# SERVICE Counselor

PACKARD MOTOR CAR COMPANY

VOL. 27, NO. 6

JUNE, 1953

Fig. 1

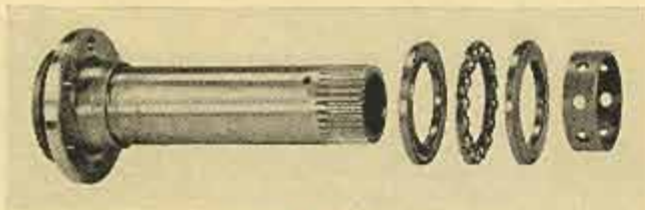
A redesigned converter reactor shaft, reactor shaft thrust washers and spacer went into production starting with Ultramatic transmission serial numbers 24267, 81346 and 219400.

Fig. 1 shows the early type converter reactor shaft, thrust ball bearing and spacer.

Fig. 2

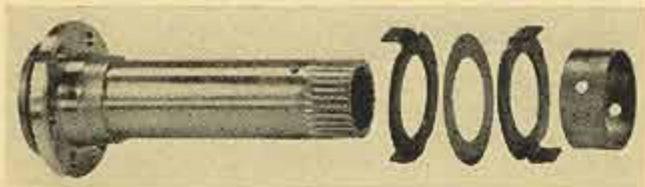
Fig. 2 shows the new type converter reactor shaft, thrust washer kit and spacer—note the longer shoulder on the new reactor shaft.

If occasion should arise whereby the converter reactor shaft is replaced on 24th, 25th and early 26th Series cars having a 9" clutch, it will be necessary to use the new type thrust washer kit omitting spacer part number 423228 which is included in the kit. The installation will be as shown in Fig. 2.
